## Operator's Manual

MODEL NO. 30196 – 890001 & UP  
MODEL NO. 30197 – 890001 & UP

## ADDENDUM

### Adjust PTO Bellcrank

**Figure 1**

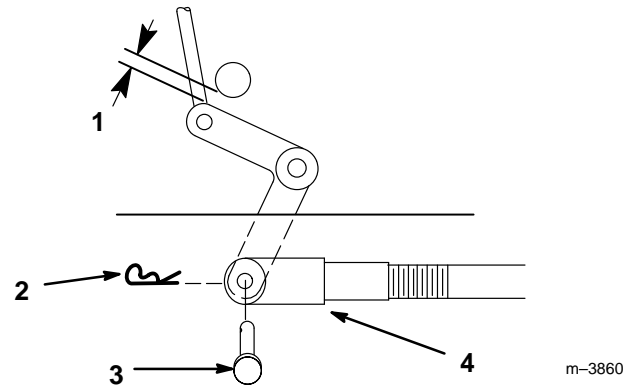
1. Engage PTO lever and check the clearance between the bellcrank and the axle shaft (Fig. 1). Space should be 1/4" (6mm).
2. If adjustment is required, remove hairpin cotter and clevis pin from bellcrank. Rotate clevis clockwise on rod to increase or counterclockwise to decrease clearance (Fig. 1).
